Trails Plan Update

Applicant	Location	Proposal
Public Works and Utilities Department, Parks and Recreation Department, Pedestrian-Bicycle Advisory Committee	City of Lincoln and surrounding area	Amend the Future Conditions: Mobility & Transportation sections to update the <u>Bicycle and Trails</u> element
Recommendation: Approval

LINCOLN AREA CURRENT AND FUTURE TRAILS NETWORK

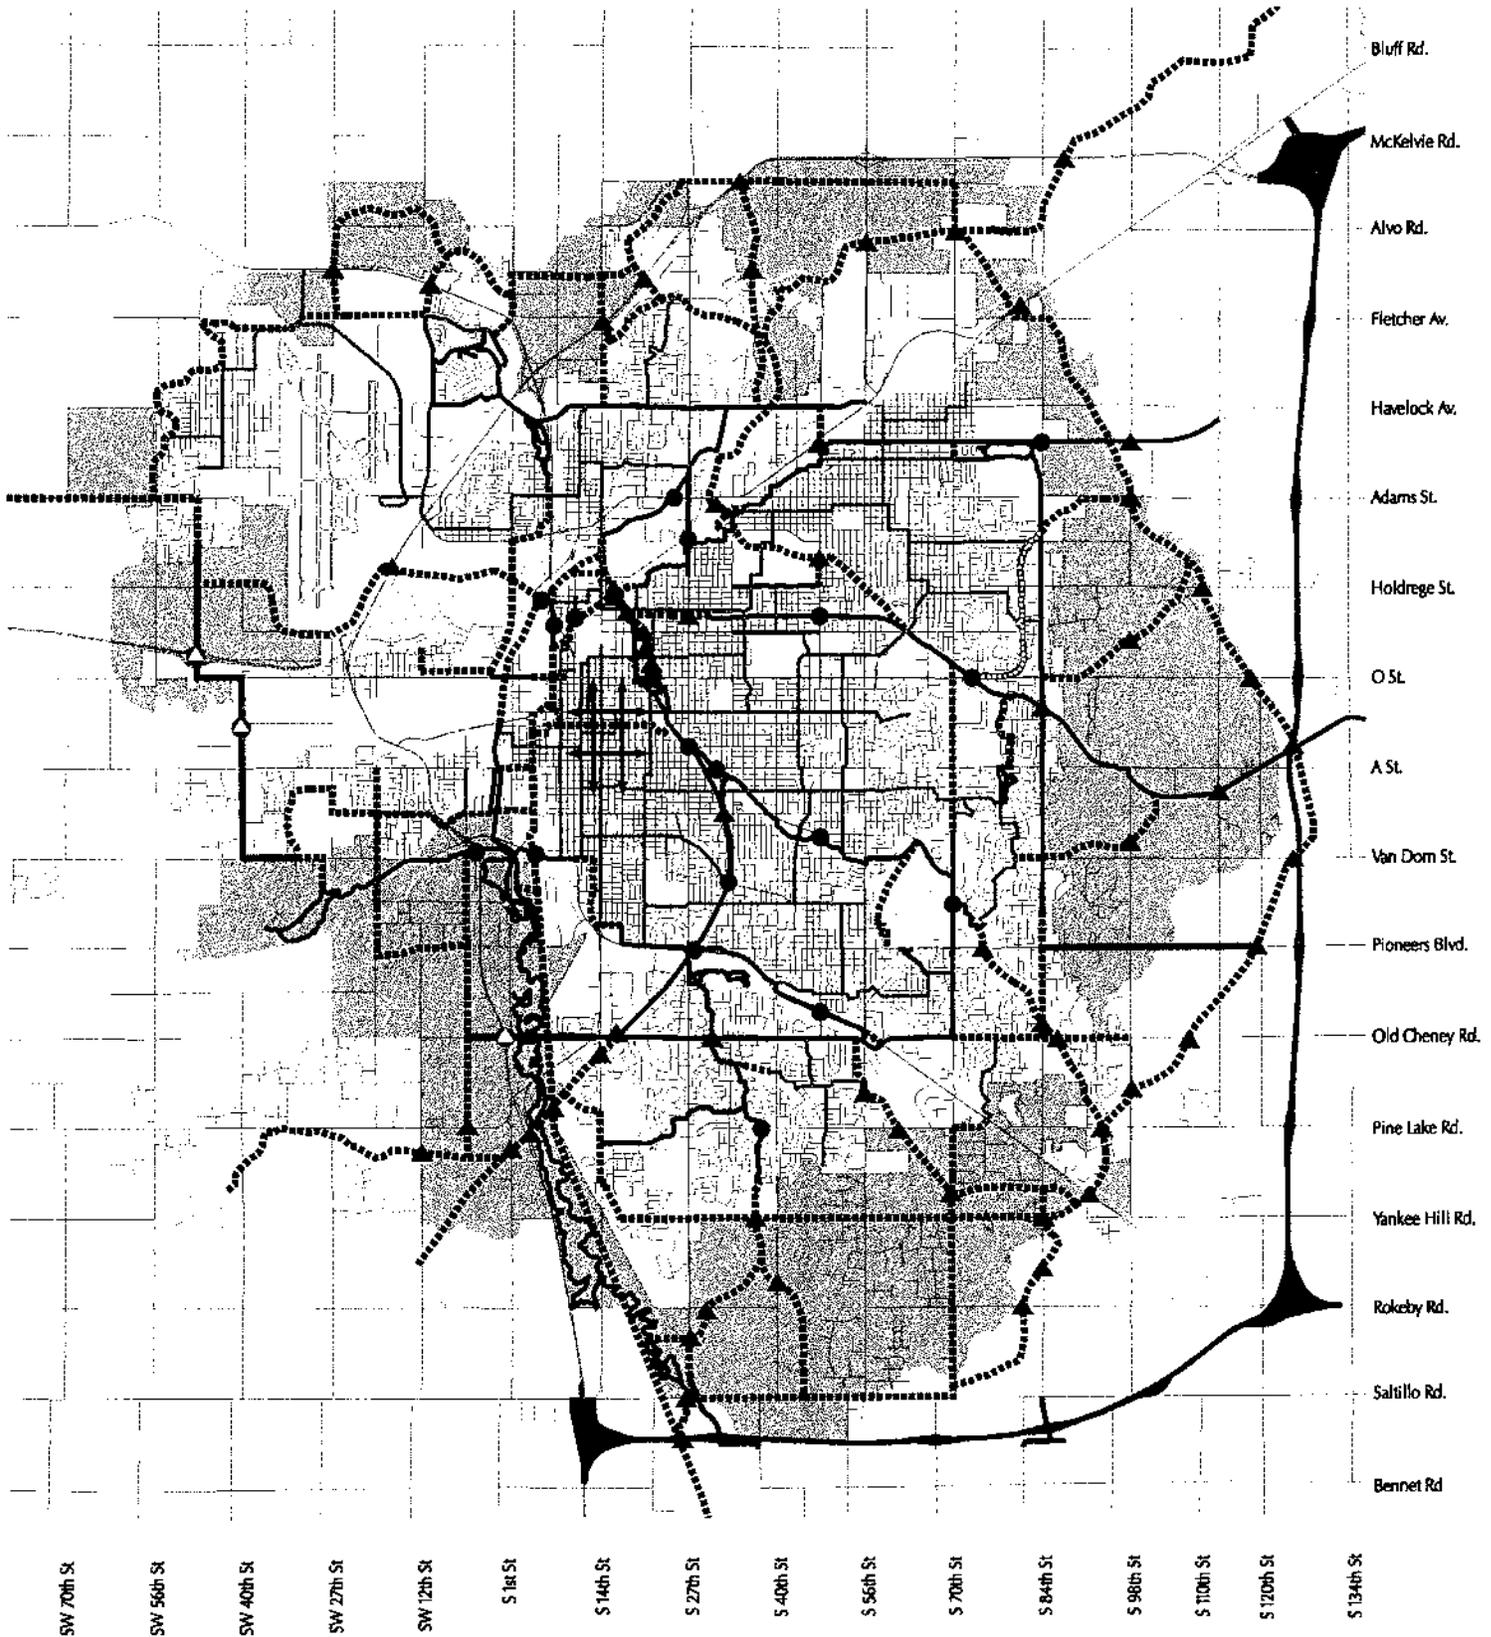
The Pedestrian and Bicycle Advisory Committee recommendations are to update the Trails & Bicycle Facilities Plan map, page F 95, and to add to the future Trail and On-Street Bike Route system as shown on the attached map. This provides for a combination of pedestrian/bicycle trails and on-street bike routes to complete a single interconnecting system.

Trail Location or On-Street Bike Route to be determined. This designation is to identify the future location for either a Future Trail corridor or On-Street Bike Route to be determined at the time of project development.

Preserve Trails ROW. This designation is to preserve a trail corridor or easement for a future trail that may not be completed within the current planing period.

This recommendation is to include all additional facility grade separations on the Trails & Bicycle Facilities Plan map on page F 95, and the following wording to guide future trail development.

The amended Trails & Bicycle Facilities Plan map will provide for a combination of pedestrian/bicycle trails and on street bike routes to complete a single interconnecting on-street route and trail system. Then new map includes two new categories “Trail Location or On-Street Bike Route to be determined” and “Preserve Trails ROW.”

The amendment also includes a new strategy on trail/arterial grade separations in order to increase pedestrian safety at all trail and arterial crossings. This amendment includes the addition of “grade separated crossings” to the Trails & Bicycle Facilities Plan map and includes the language to guide future trail/arterial crossing development where trail/arterial street intersections do not coincide with arterial/arterial street crossings.

1. Amend the Trails & Bicycle Facilities Plan map, page F 95, to add to the future Trail and On-Street Bike Route system as shown on the attached map.
2. Amend the strategies on page F 95 to add the following:

“Grade separated crossings are to be considered in conjunction with all new construction and reconstruction of transportation projects at all trail/arterial street intersections that do not coincide with arterial/arterial street crossings.”
